Attachment 4

ADG Compliance Table

Design Criteria	Required	Proposed	Compliance															
	<div></div> <div><div><p>Figure 17: Area Calculations</p></div><div><p><u>AREA CALCULATIONS</u></p>

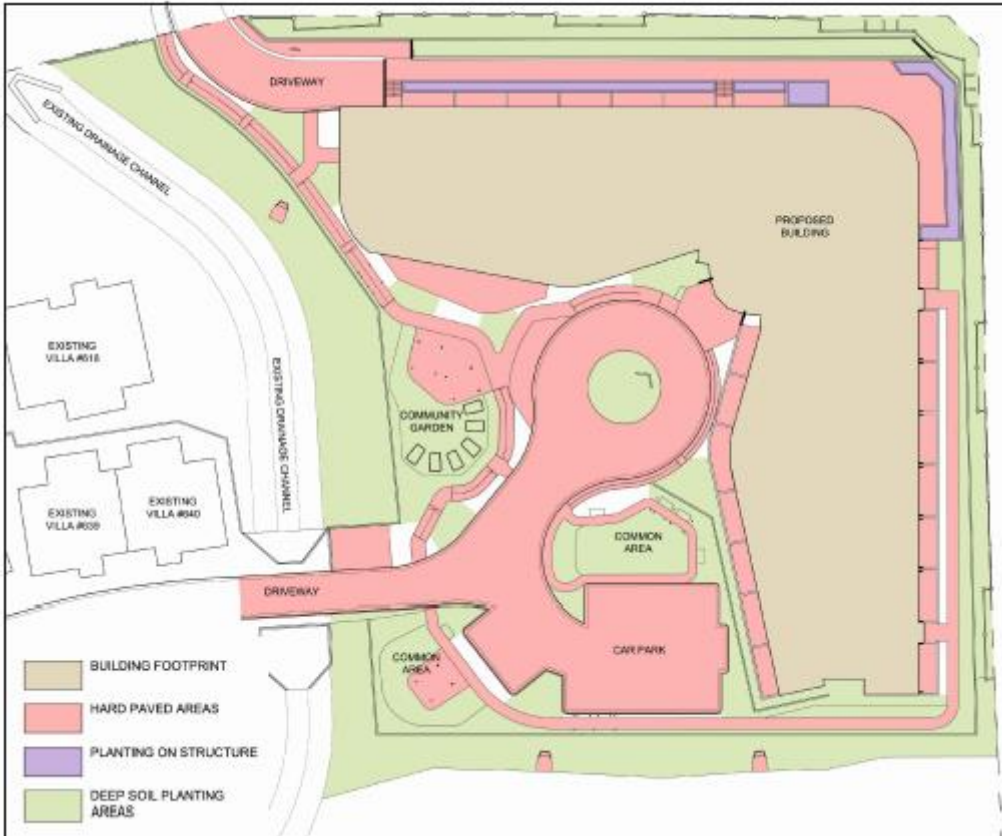
Design Criteria	Required	Proposed	Compliance
3D-1 Communal Open Space	<p>Minimum communal open space area 25% of the site.</p> <p><u>Note:</u></p> <p>For the purposes of this assessment, calculation has utilised the development sites area of 10,027m² and not the total site area of 217,300m².</p>	<p>The size, location and design of communal or public open space will vary depending on the site context and the scale of development. The function of open space is to provide amenity in the form of:</p> <ul style="list-style-type: none"> • landscape character and design; • opportunities for group and individual recreation and activities; • opportunities for social interaction; • environmental and water cycle management; • opportunities to modify microclimate; and • amenity and outlook for residents. <p>The principal part of the communal open space area may be supplemented by:</p> <ul style="list-style-type: none"> • additional landscape area, circulation space and areas for passive use and outlook; and • public land used for open space and vested in or under the control of a public authority. <p>There are three principal communal open space areas at ground level located in the western portion of the development area (refer to Figure 17). In excess of 25% the development sites area is dedicated as communal open space, including a community garden, outdoor dining areas and multiple common greens.</p>	Yes
